Surface Water Baseline and Impact Assessment Report for the Proposed 75 MW PV 1 Solar Facility (Proposed Bokpoort II Solar Development) near Groblershoop, Northern Cape

Report Number: 1400951-300592-9

RESPONSE TO MEMO: PV1 SURFACE WATER STUDY TECHNICAL REVIEW

Figure 10: Average Temperature (°C) Graph for Groblershoop.

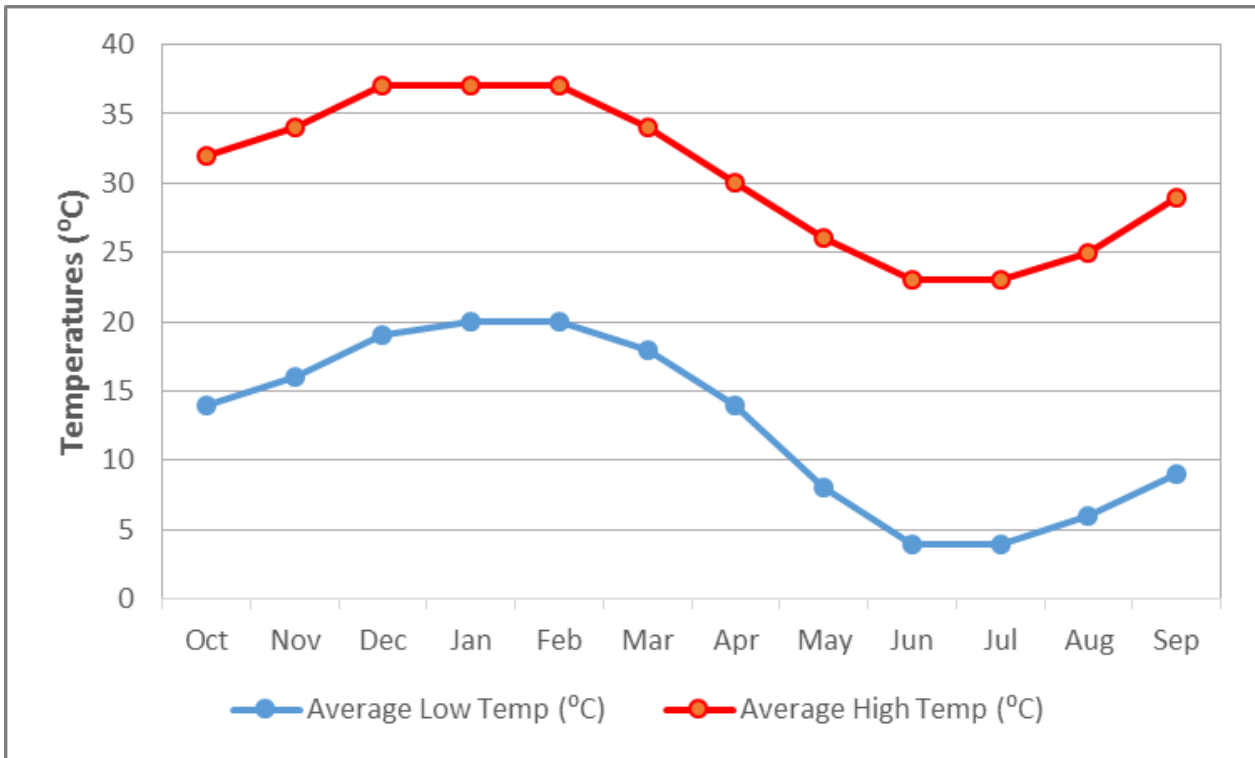
Review Comment	Action Taken
No temperature data is shown in the document, as mentioned in the scope of work.	The report now includes a section 7.0 to incorporate temperature data.
Figure numbers are missing and incorrectly referenced in the text.	Figure numbers are now present and correctly referenced.
It is unclear how the peak rainfall data was obtained.	Section 6.0 has been reworked to provide additional resolution on how the peak rainfall data was obtained. The best fit graph was changed to the Extreme Value Type 1 distribution. This does not impact the storm water management plan design.
The text at the bottom of page 10 has the incorrect font and refers to the incorrect table.	Text throughout the document is now consistent. Incorrect table references have been rectified.
The document lacks a project description that can inform the reader of what activities will be undertaken on the project site. It is assumed that this document will be read in conjunction with other sections of the EIA which will probably have a detailed project description.	It is recommended that this document be read in conjunction with other sections of the EIA to ensure a better understanding.

Temperature data was sourced for the Groblershoop area to represent the site area (World Weather Online, 2016) Temperature data is seen graphically in Figure 10. High average summer temperatures in the months of September to March range between 29^oC and 37^oC with winter temperatures in the months April to August ranging between 23^oC and 30^oC. Low average temperatures range between 14^oC and 20^oC with winter temperatures ranging between 4^oC and 9^oC.

Figure 13: Proposed storm water management plan for the PV1 Facility

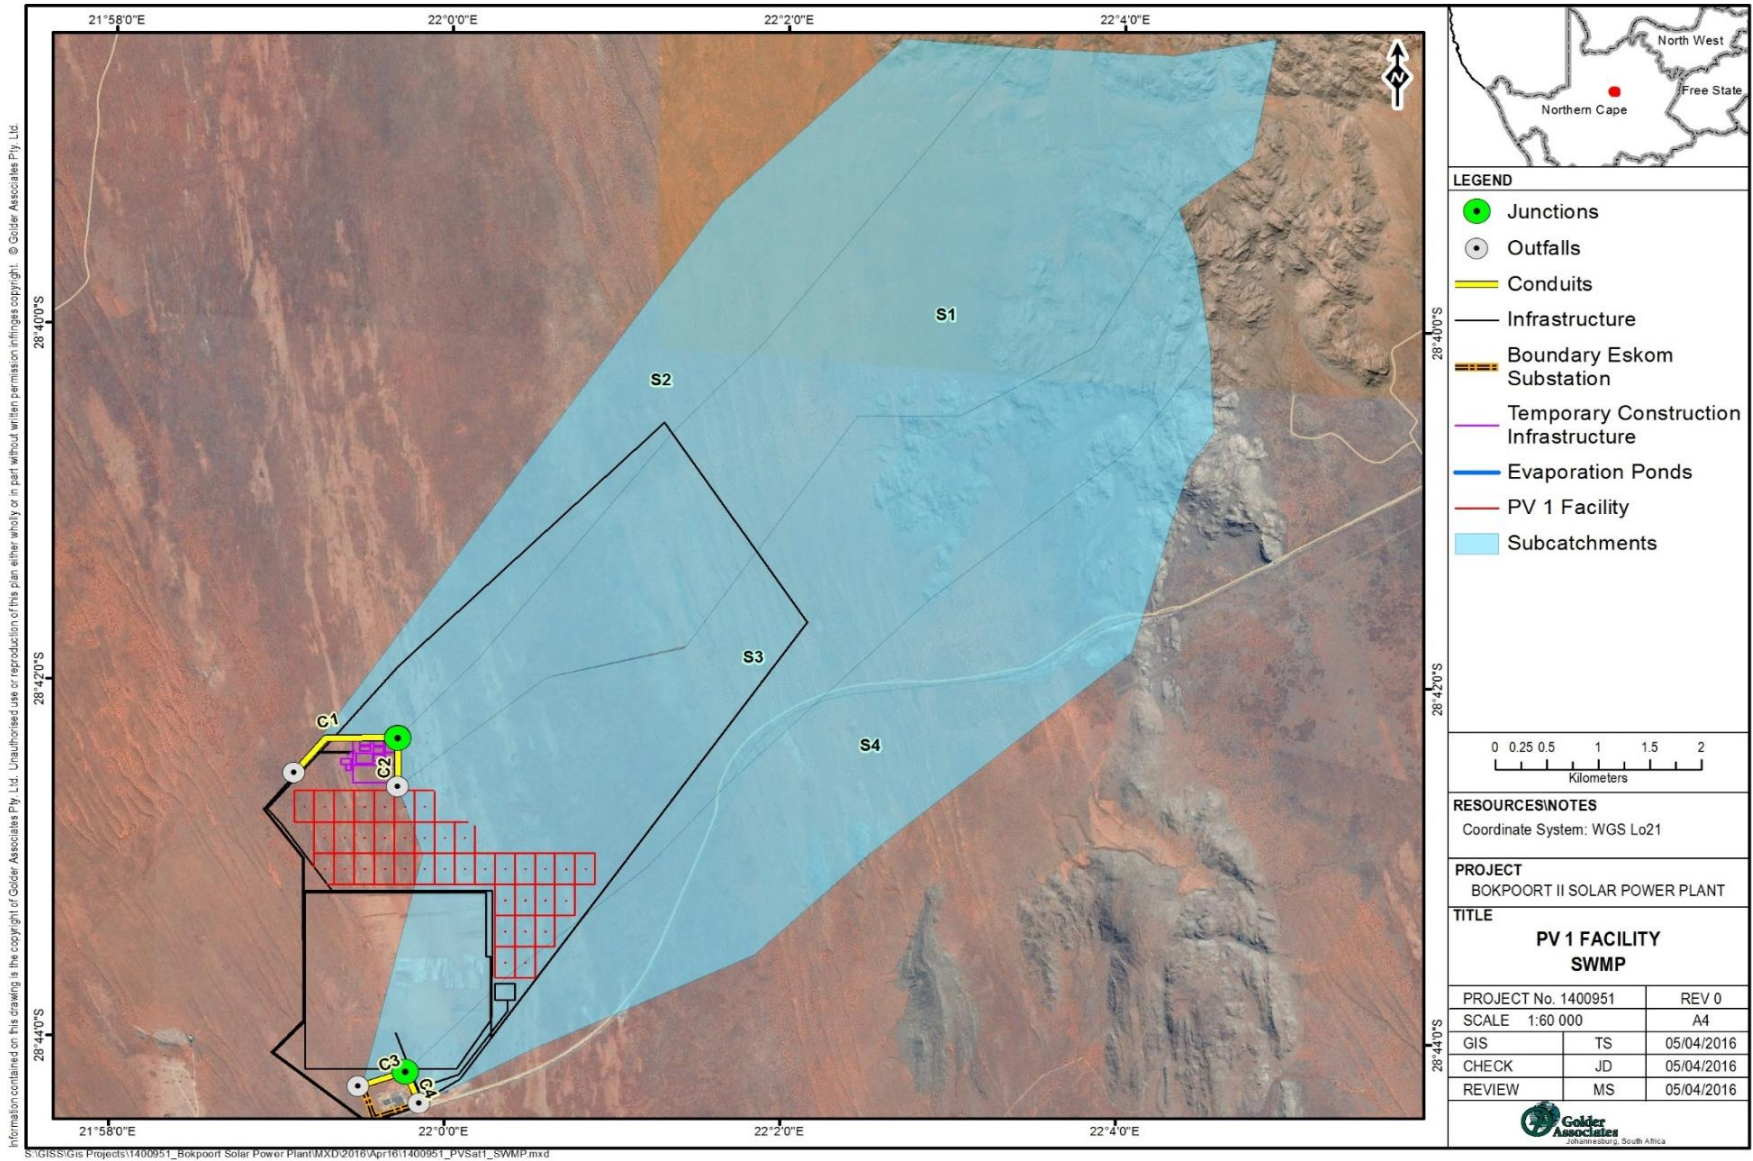
Review Comment	Action Taken
<p>It is unclear on whether the storm water diversion trenches are lined or not,</p> <p>If trenches are unlined: The flow velocities associated with the 50-year storm flows are considered to be at the upper end of acceptability for channels C2 and C4, but no excessive erosion is foreseen.</p>	<p>A description has been included to describe the type of channel used during modelling under section 11.2.2 Channel characteristics.</p>
<p>It is suggested that a paragraph be inserted on the maintenance of the channels – channels should be kept free of woody vegetation and should be inspected for erosion damage periodically.</p>	<p>This suggestion has been incorporated into a new section entitled: 11.2.3. Erosion control.</p>
<p>No indication of how localised erosion will be prevented at the storm water channel diversion outlets. This is a requirement by the DWS when issuing water use licences and should be included in this document at least in concept form or as a principle.</p>	<p>Localised erosion has now been accounted for in concept form and can be found in section 11.2.3.</p>

The flow velocities associated with the 50-year storm are considered to be at the upper end of acceptability for channels C2 and C4 but no excessive erosion is foreseen. Channels should be kept free of woody

vegetation and should be inspected for erosion damage periodically such that corrective measures can be taken, should high erosion damage occur.

If high erosion damage is identified, the following outlet protection devices and energy dissipaters should provide sufficient protection and should be investigated which is most appropriate:

- Rip rap outlet Basins
- Stone pitching
- Gabions
